### World Forum for Harmonization of Vehicle Regulations

## **Proposal for Supplement 1 to the 01 series of amendments of UN Regulation No. 154**

### **Submitted by the representatives of the European Commission and Japan \*, \*\***

The text reproduced below is a proposal for Supplement 1 to the 01 series of amendments of UN Regulation No. 154 on uniform provisions concerning the approval of light duty passenger and commercial vehicles with regards to criteria emissions, emissions of carbon dioxide and fuel consumption and/or the measurement of electric energy consumption and electric range (WLTP). It corrects errors and clarifies provisions based on requirements introduced in the Amendment 6 to UN GTR No. 15. This document is subject to review by GRPE during its January 2021 session. This document is submitted to the World Forum for Harmonization of Vehicle Regulations (WP.29) and its Administrative Committee for the 1958 Agreement (AC.1) for consideration and vote at their March 2021 sessions.

"Figure 8/1

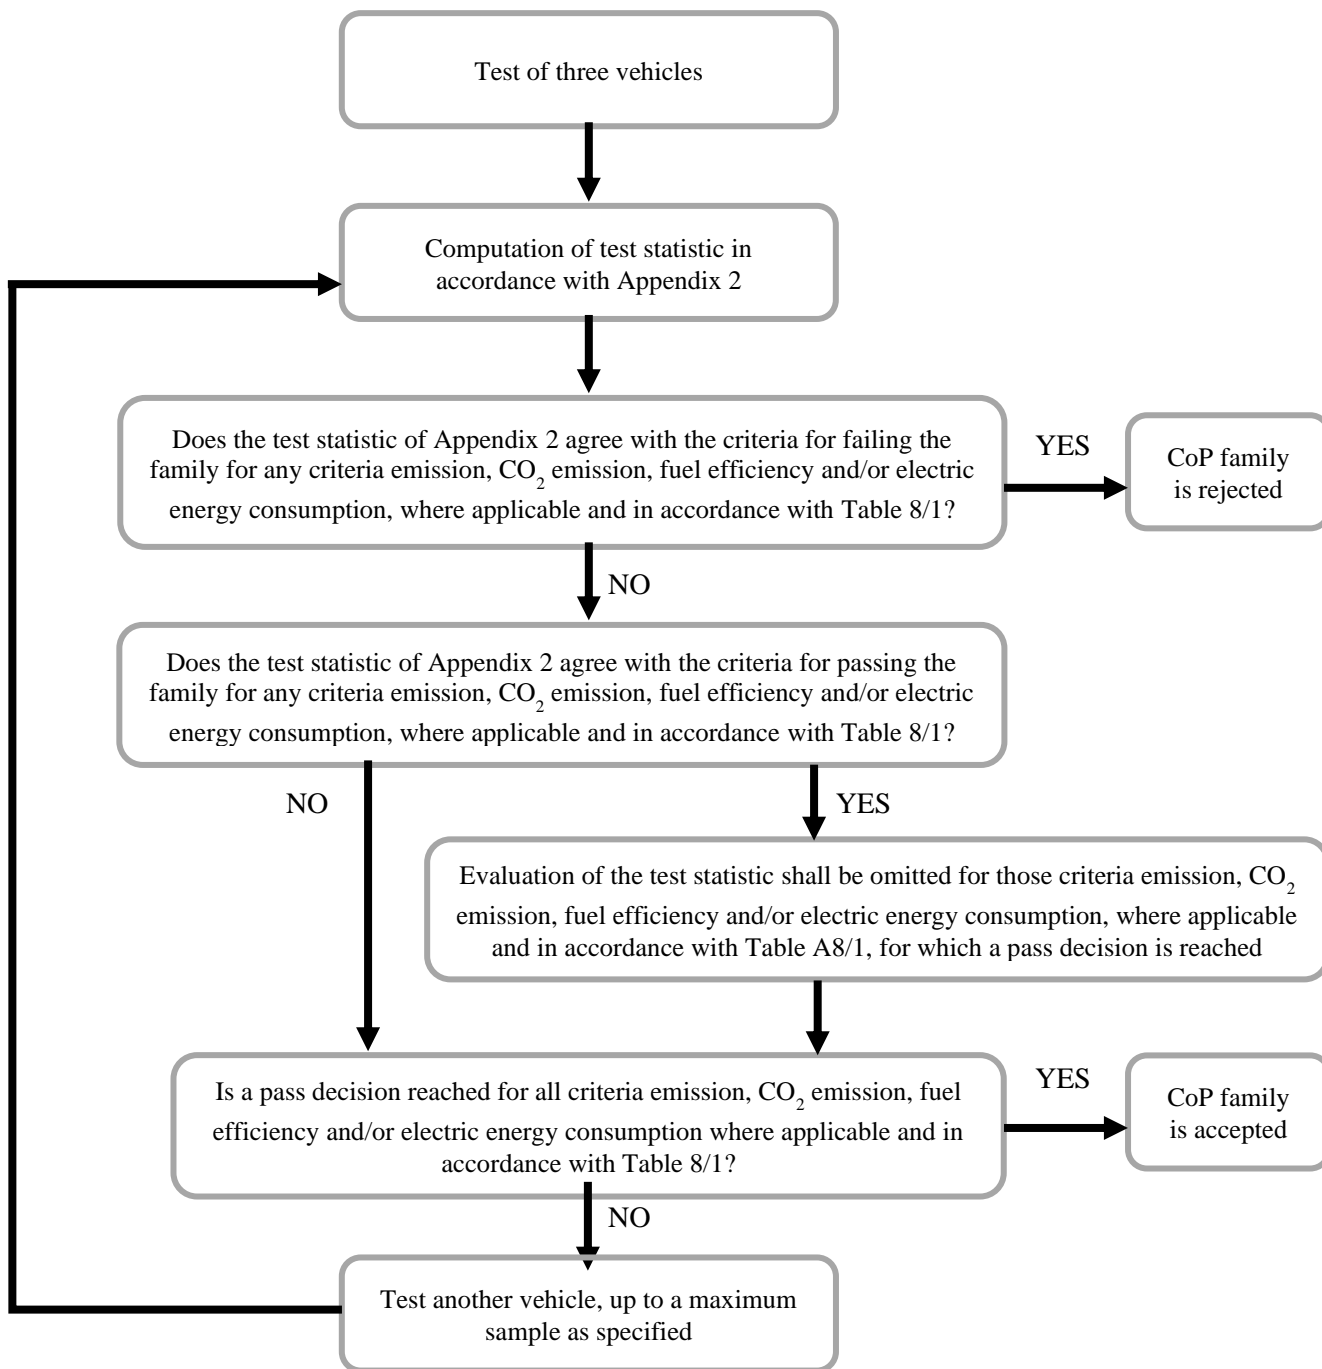
Paragraph 8.2.3.2., Figure 8/1, amend to read:

Figure A6/4

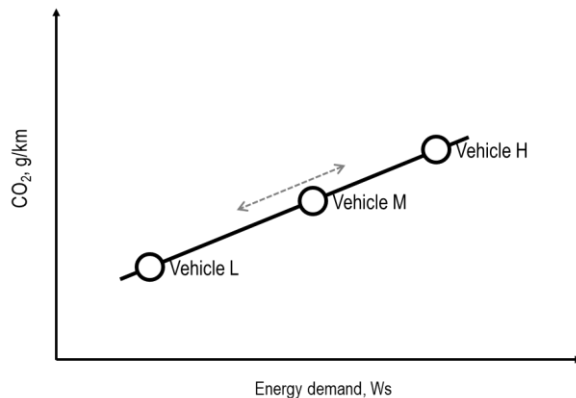
Paragraph 2.3.2.4., amend to read:

"2.3.2.4. Vehicle M is a vehicle within the interpolation family between the vehicles L and H with a cycle energy demand which is preferably closest to the average of vehicles L and H.

The limits of the selection of vehicle M (see Figure A6/4) are such that neither the difference in CO<sub>2</sub> emission values between vehicles H and M nor the difference in CO<sub>2</sub> emission values between vehicles M and L is greater than the allowed CO<sub>2</sub> range in accordance with paragraph 2.3.2.2. of this annex. The defined road load coefficients and the defined test mass shall be recorded.

Figure A8/2

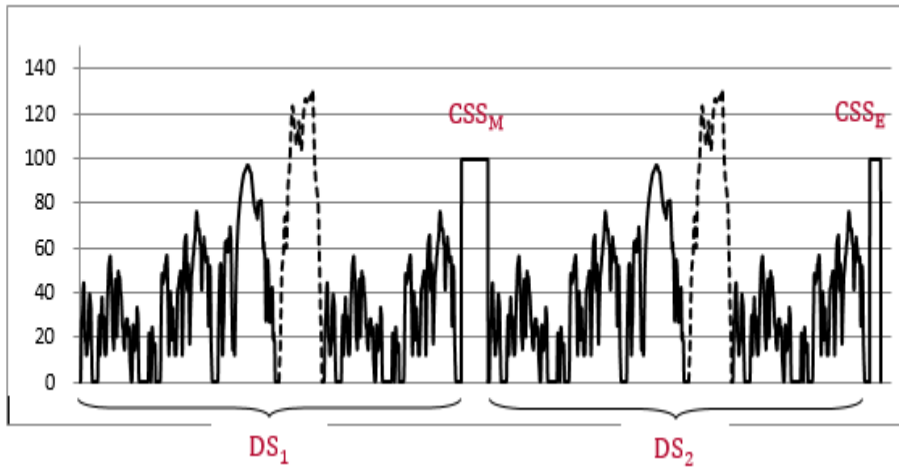
Paragraph 3.4.4.2.1., amend to read:

"3.4.4.2.1. Speed trace

The shortened Type 1 test procedure consists of two dynamic segments (DS<sub>1</sub> and DS<sub>2</sub>) combined with two constant speed segments (CSS<sub>M</sub> and CSS<sub>E</sub>) as shown in Figure A8/2.

Figure A8/5

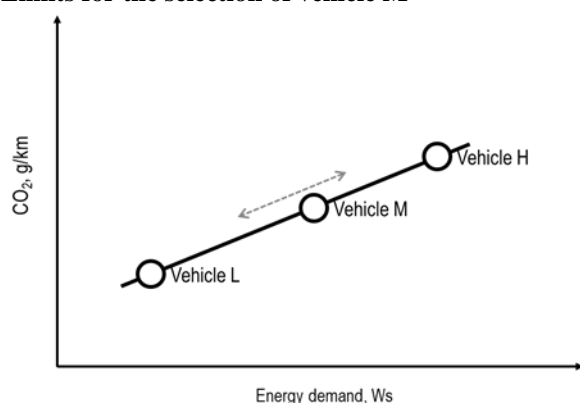
**Limits for the selection of vehicle M****For 4-phase WLTP**

The linearity of the corrected measured and averaged charge-sustaining CO<sub>2</sub> mass emission for vehicle M,  $M_{CO_2,c,6,M}$  according to step 6 of Table A8/5 of Annex B8, shall be verified against the linearly interpolated charge-sustaining CO<sub>2</sub> mass emission between vehicles L and H over the applicable cycle by using the corrected measured and averaged charge-sustaining CO<sub>2</sub> mass emission  $M_{CO_2,c,6,H}$  of vehicle H and  $M_{CO_2,c,6,L}$  of vehicle L, according to step 6 of Table A8/5 of Annex B8, for the linear CO<sub>2</sub> mass emission interpolation.
